## Shafer

## Technical Bulletin MPH-0297

## **Subject: Manual hydraulic pumps**

Figure 4

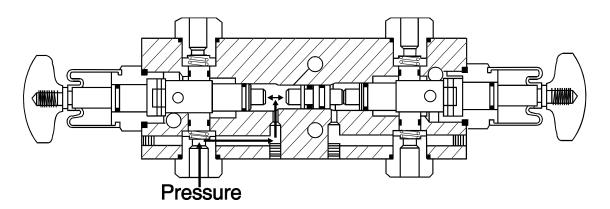
The balanced ram design incorporated in the new pumps simply means that the area on top of the pump piston is exactly the same as the area underneath (fig. 4). This "balanced" ram prevents the ram from any movement in the event an internal seal failure allows pressure into the suction/discharge area of the pump.

Caution: Never store the pump handle in the clevis of any hand pump that does not have a balanced ram design..

Figure 6

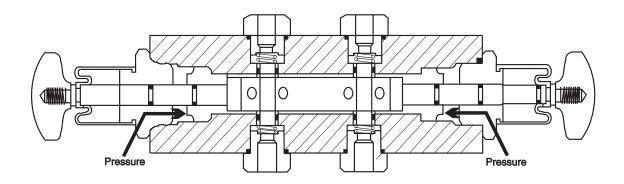
If the standard Central/Hydraulic pump is left selected to either the open or close mode and the actuator needs to be stroked using power oil, the hydraulic pressure enters cross drillings in the selector body (fig. 6) and returns the selector sleeve to the centered, or automatic, position opening the hydraulic flow paths allowing the actuator to stroke. The hydraulic pressure will return the pump to the neutral or automatic position regardless of wether the pump was selected to the open or close pumping mode.
